PLAN NO - CE/Y/21/2021

PS ITEM NO.52 OF 2015-16
THIS PLAN SUPERSEDES PLAN NO.02/Y/16/2017

N.F.RAILWAY/ KATIHAR DIVISION
PLAN NO.KIR/Y/02/2017

AT/ALIP
PROPOSED REMODELING OF EXISTING PLATFORM LINES WITH MODIFICATION & REQUIREMENT AT STN & YARD.

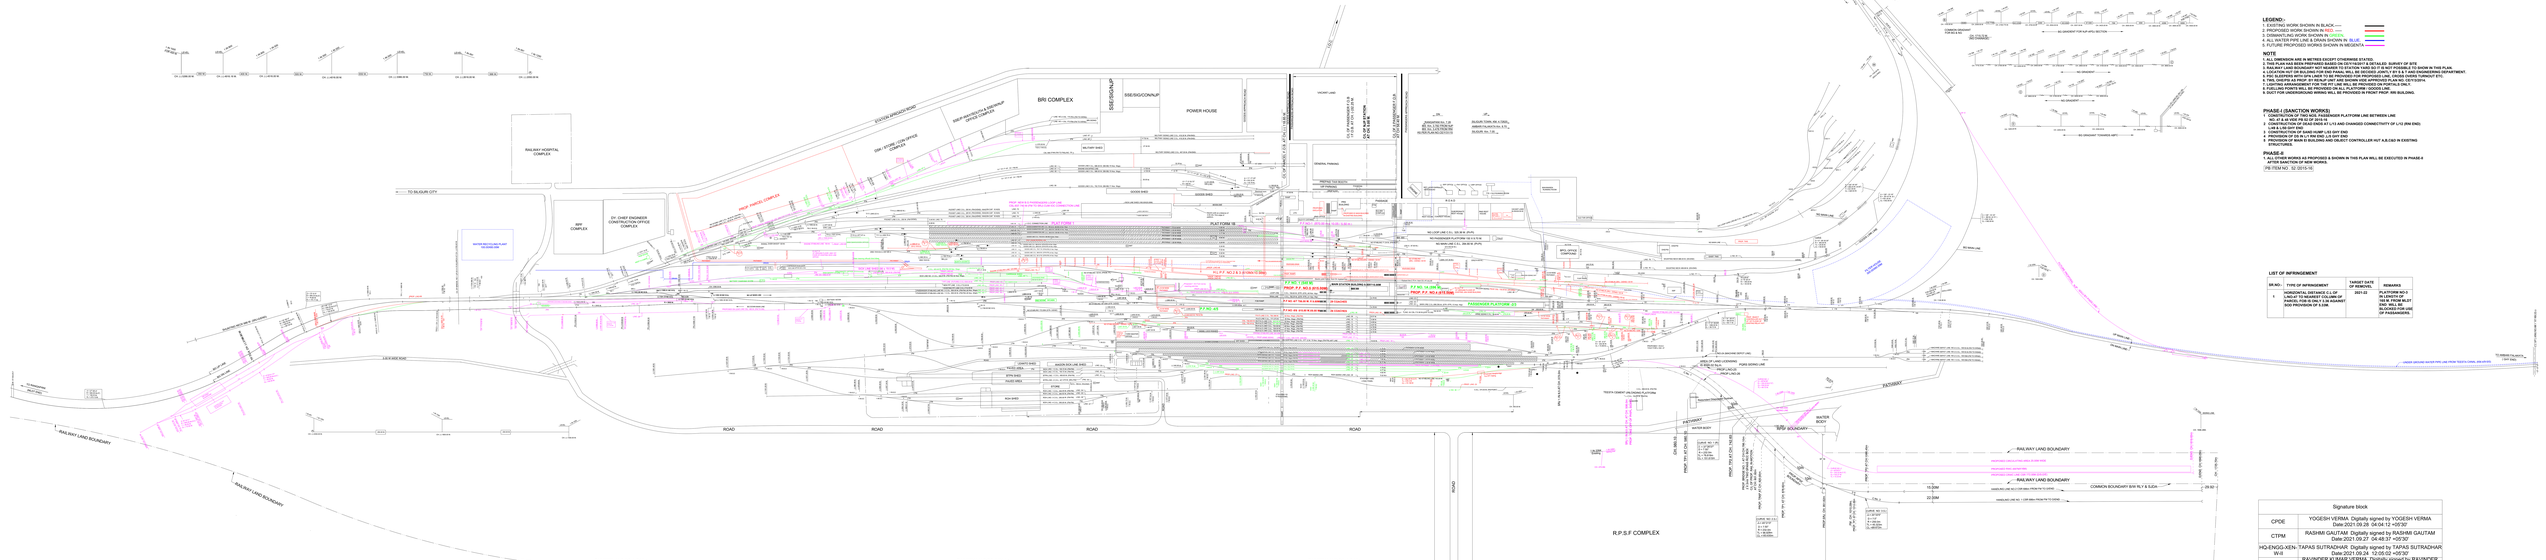
ALT 1

(a) ONE D/END PROPOSED ON LINE NO. 13 AT ABFC END , ACCORDINGLY CSL OF L/11 & L/12 ARE CORRECTED AND CROSSOVER PROVIDED.

(b) ONE D/S PROPOSED ON LINE NO. 9 AT RNI END AND ACCORDINGLY CSL CORRECTED.

ALTERATIONS ARE DONE AS PER GM/ S&T MLG.S LETTER NO. N/225/3480 AND DT. 08/11/2021.

ALT 2

(a) INCLSION OF DS IN ENGINE STABLING LINE (ON PROPOSED L/No.70 AT RNI END).

(b) PROVISION OF DEAD END AT L/S2 AT RNI END. BY SHIFTING OF POINT NO 201 FROM 856.61M TO 886.67M.

(c) DELETION OF DS AND ENGINE STABLING LINE NEAR POINT NO.175A (1 IN 8.5) AT RNI END.

ALTERATIONS ARE DONE AS PER CRS/S.E. CIRCLE/KOLKATA L.No. 71A/SV/VI/PIN/JP/KIR/1921, DT.28.03.2022.
